# NEWMAR CORPORATION WARRANTY DEPARTMENT

<b>TECHNICAL SERVICE BULLETIN</b>																	
DATE ISSUED	MODEL YEAR(S) AFFECTED		MODEL(S) AFFECTED			TSB #											
2/17/09	2004 - 2009		ATME, DADP DSDP, KSDP, MADP, VTDP			360											
BRAND						TYPE											
All <input type="checkbox"/>	American Star <input type="checkbox"/>	Mountain Aire <input checked="" type="checkbox"/>	All <input type="checkbox"/>	TT <input type="checkbox"/>													
Cypress <input type="checkbox"/>	Dutch Star <input checked="" type="checkbox"/>	Kountry Aire <input checked="" type="checkbox"/>	FW <input type="checkbox"/>	CA <input type="checkbox"/>													
Northern Star <input checked="" type="checkbox"/>	Kountry Star <input checked="" type="checkbox"/>	Essex <input checked="" type="checkbox"/>	DP <input checked="" type="checkbox"/>	DB <input type="checkbox"/>													
Scottsdale <input type="checkbox"/>	King Aire <input type="checkbox"/>	London Aire <input type="checkbox"/>															
All Star ME <input checked="" type="checkbox"/>	Ventana <input checked="" type="checkbox"/>	Bay Star <input type="checkbox"/>

## RECALL SERVICE BULLETIN

**SUBJECT:** Hitch

**TRAILER HITCH MOUNTING**  
**FIG. 4-1**

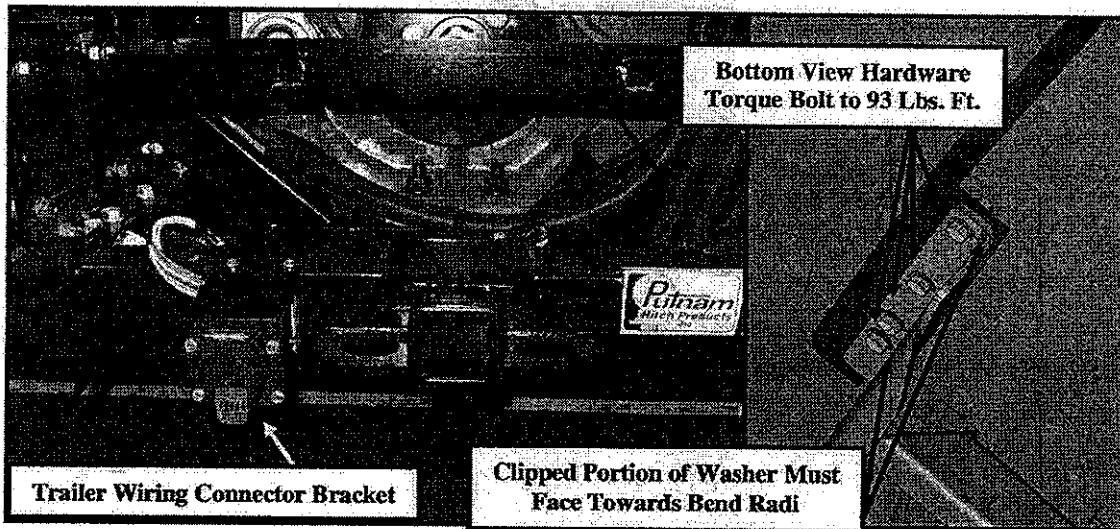
**CONDITION:** End plates on trailer hitches are fracturing at the 90 degree bend of the mounting flange.

**CAUSE:** Radii too sharp causing high amount of stress in the bend area

**CORRECTION:** Replace trailer hitch

1. Observe all applicable industry safety standards and secure vehicle to allow for installation of a new trailer hitch.
2. Refer to FIG. 4-1. If trailer hitch is equipped with a trailer wiring connector mounting bracket, make note of its location and remove bracket from hitch. Retain bracket and hardware for reuse.
3. Remove trailer hitch from vehicle and discard mounting hardware. Cut trailer hitch in two and properly discard trailer hitch.
4. Refer to FIG. 4-1. Install new trailer hitch using new mounting hardware. Bolts must be installed from bottom side (bolt head toward ground) with clipped flat washer installed between bolt head and mounting flange of hitch with clip toward bend. Torque nuts to 74 lbs. ft., or from bolt head side 93 lbs. ft.

**NOTE:** The new trailer hitch is taller than the original trailer hitch which may create an interference with the tow guard. Modify the tow guard as necessary. If the tow guard is mounted beneath the trailer hitch it must be removed before trailer hitch is removed. Clearance between tow guard and ground should not be altered. Reinstall tow guard after new trailer hitch is installed.

5. Refer to FIG. 4-1. If a trailer wiring connector mounting bracket was removed from the original hitch locate the connector mounting bracket on the new trailer hitch in the same location as it was on the original hitch and secure as needed.
